**RE: December 1, 2021 Meeting  
64 Vaughan Mall Restoration  
Portsmouth, NH 03801**

Attention: Historic District Commission  
RE: 64 Vaughan Mall (LU-20-214)

The applicant for the Restoration of 64 Vaughan Mall wishes to review the following discussion points at the December 1, 2021 Public Hearing in regards to the stipulations and open items for the project.

1 SOUTH ELEVATION - HDC  
1/16" = 1'-0"

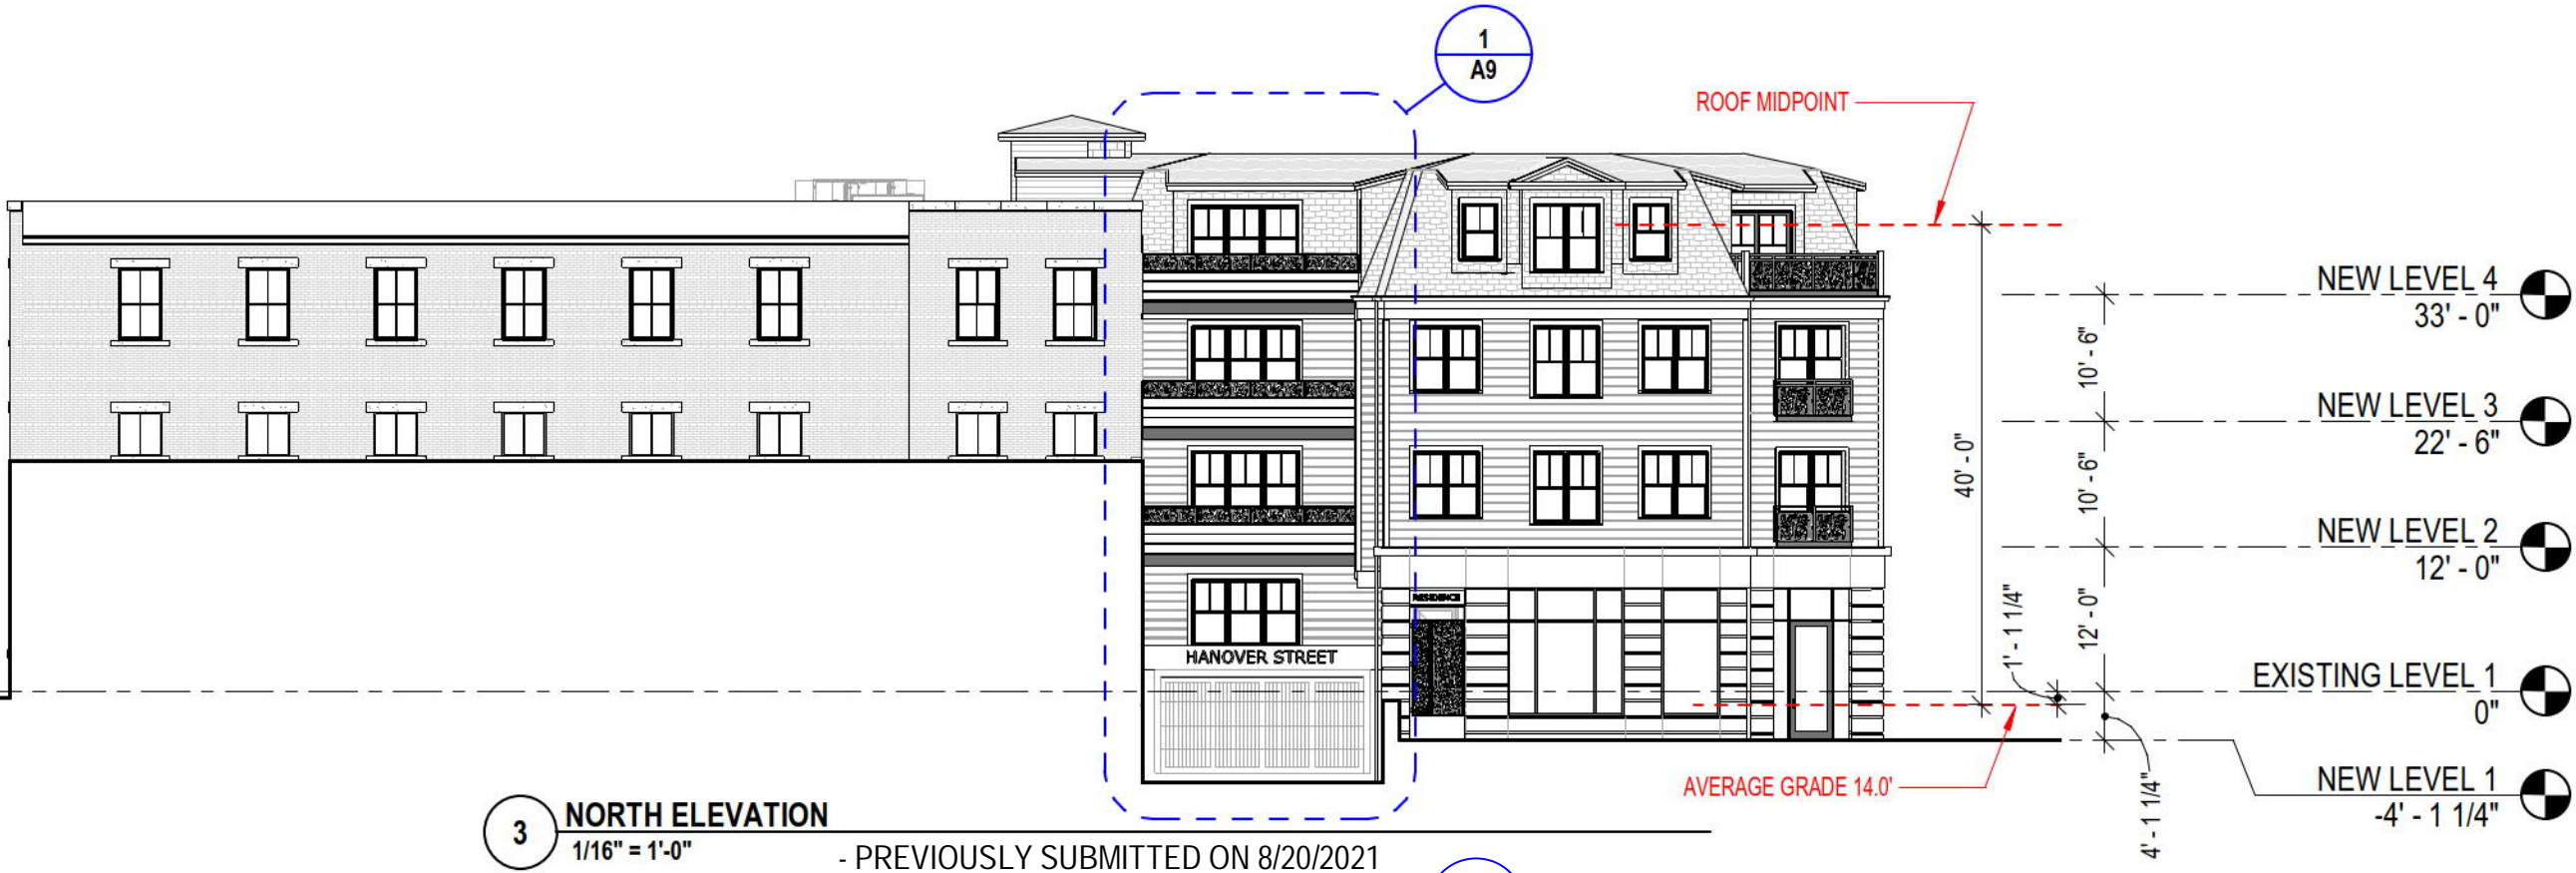
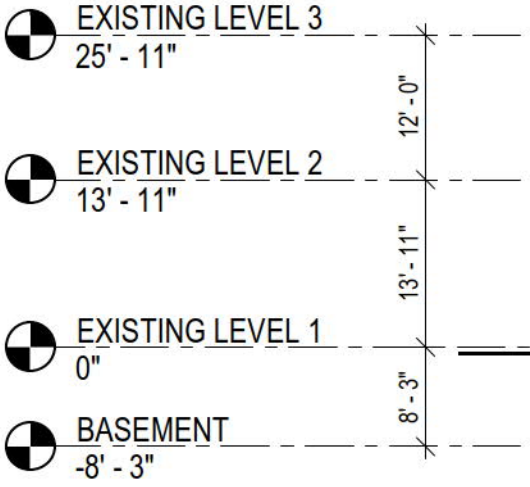
1. HANOVER STREET ENTRY AND RAMP REMOVED. REPLACED 5 METAL PANELS WITH 4 STOREFRONT WINDOW SYSTEMS
2. REVISED LAYOUT OF STOREFRONT AT VAUGHAN MALL ENTRANCE.
3. REMOVED EXTERIOR DECKS.
- 3A. INFILL OF DECK WITH INTERIOR FLOOR
4. MOVED EXTERIOR WALLS TO ALIGN WITH FIRST FLOOR EXTERIOR BELOW.
5. RELOCATED MECHANICAL ROOF UNITS.
6. CENTERED WINDOWS.
7. RESIZED WINDOWS AND CENTERED WINDOWS.
8. ADDED HORIZONTAL MULLIONS TO STOREFRONTS.

4 WEST ELEVATION - HDC  
1/16" = 1'-0"

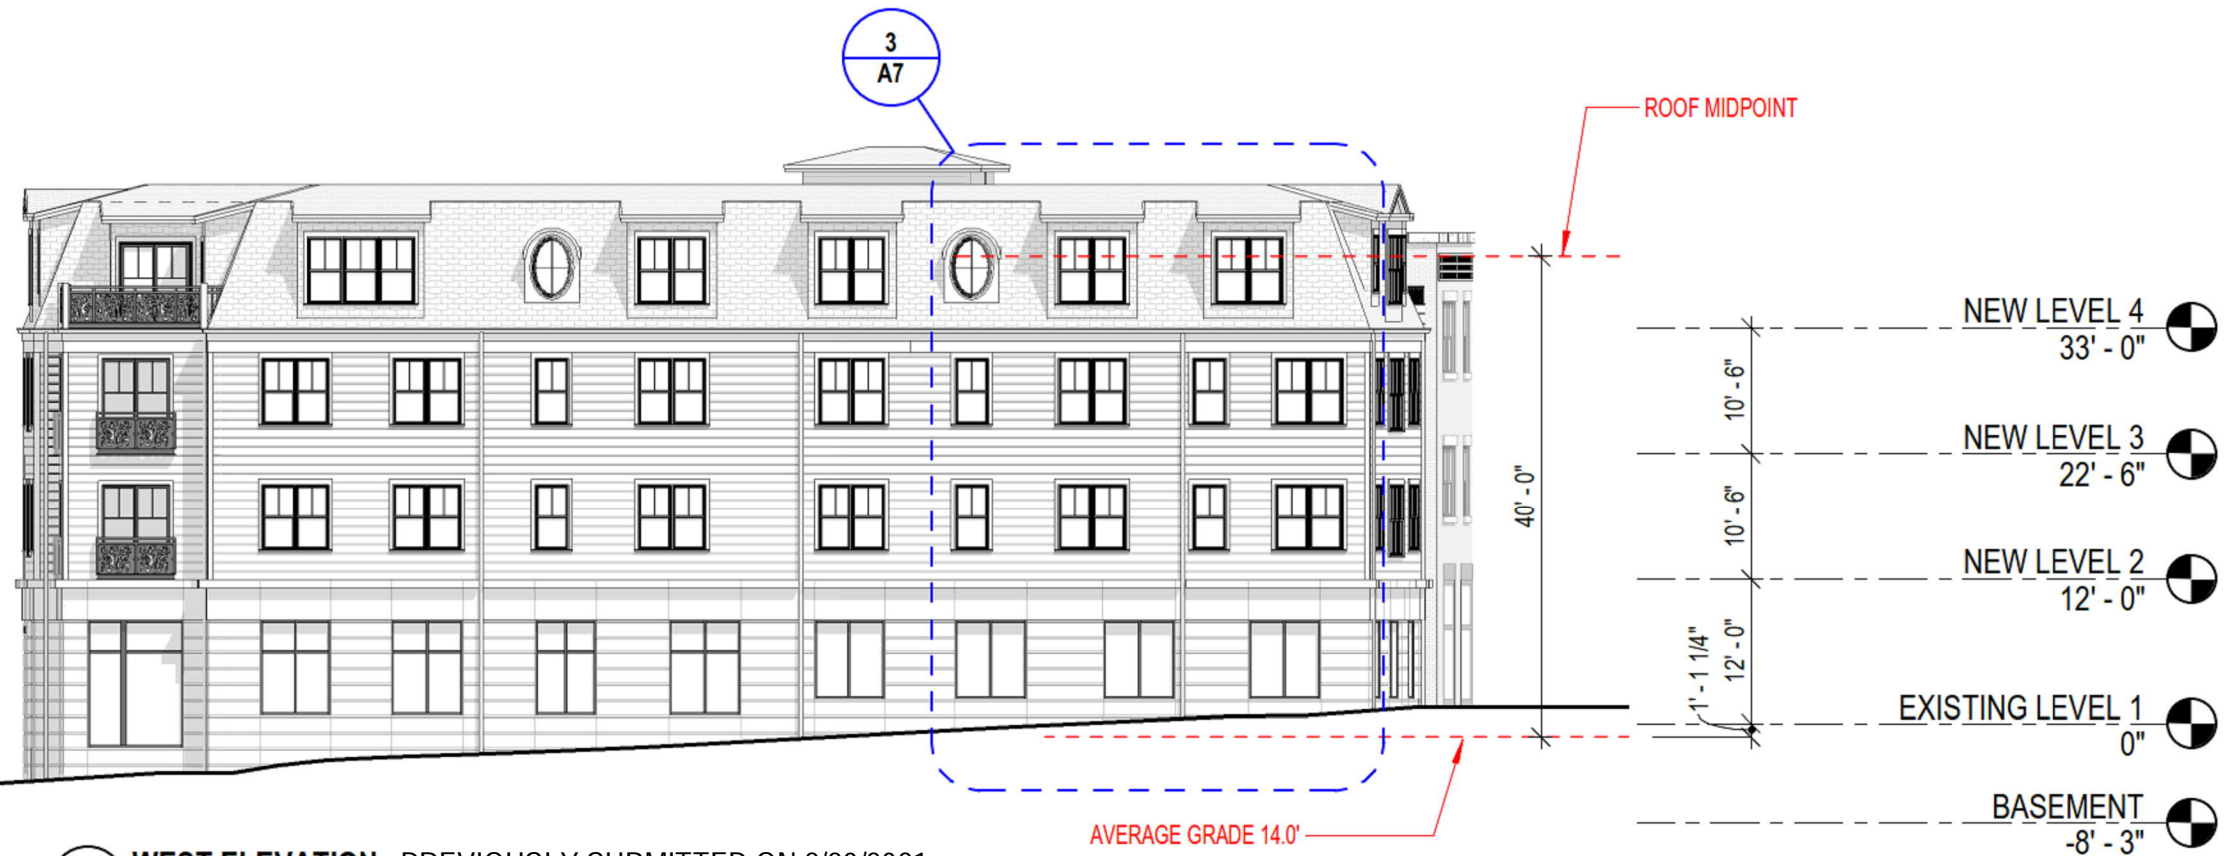
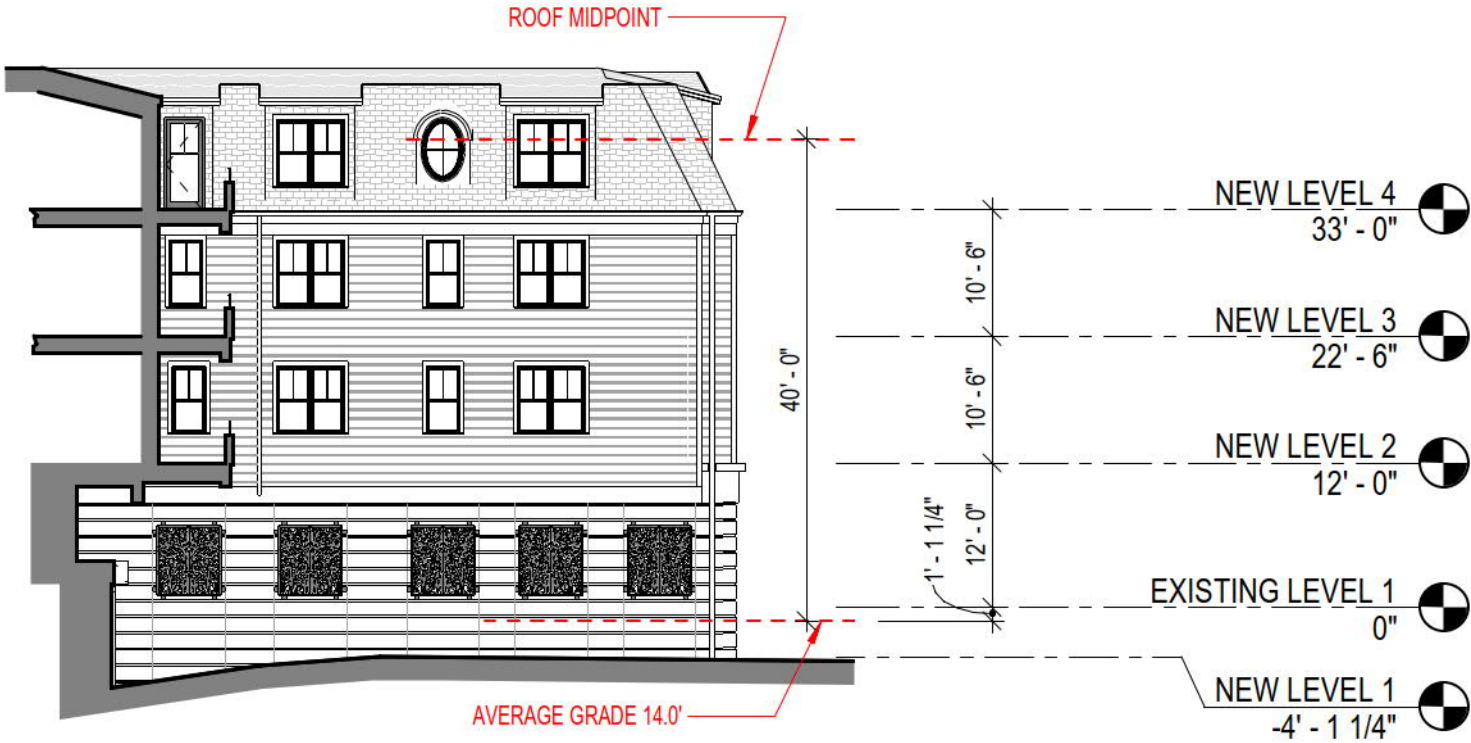
1. HANOVER STREET ENTRY AND RAMP REMOVED. REPLACED 5 METAL PANELS WITH 4 STOREFRONT WINDOW SYSTEMS.
2. REVISED LAYOUT OF STOREFRONT AT VAUGHAN MALL ENTRANCE.
3. REMOVED EXTERIOR DECKS.
- 3A. INFILL OF DECK WITH INTERIOR FLOOR
4. MOVED EXTERIOR WALLS TO ALIGN WITH FIRST FLOOR EXTERIOR BELOW.
5. RELOCATED MECHANICAL ROOF UNITS.
6. CENTERED WINDOWS.
7. RESIZED WINDOWS AND CENTERED WINDOWS.
8. ADDED HORIZONTAL MULLIONS TO STOREFRONTS.

5 EXTERIOR ELEVATIONS - EAST ELEVATION @ DRIVEWAY - HDC  
1/16" = 1'-0"

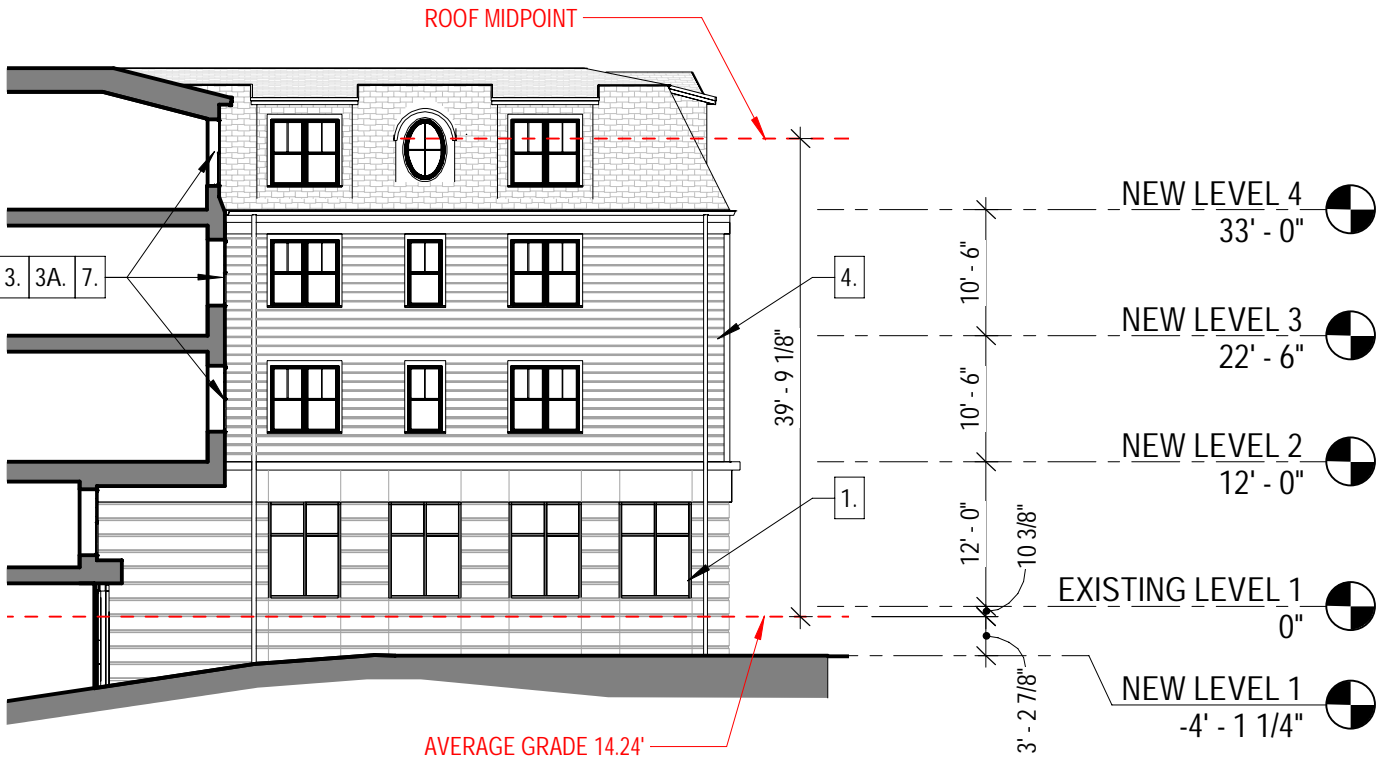
| HDC REVISION KEY NOTES |  |
|------------------------|--|
| 1.                     | HANOVER STREET ENTRY AND RAMP REMOVED. REPLACED 5 METAL PANELS WITH 4 STOREFRONT WINDOW SYSTEMS. |
| 2.                     | REVISED LAYOUT OF STOREFRONT AT VAUGHAN MALL ENTRANCE.   |
| 3.                     | REMOVED EXTERIOR DECKS.  |
| 8.                     | ADDED HORIZONTAL MULLIONS TO STOREFRONTS.  |
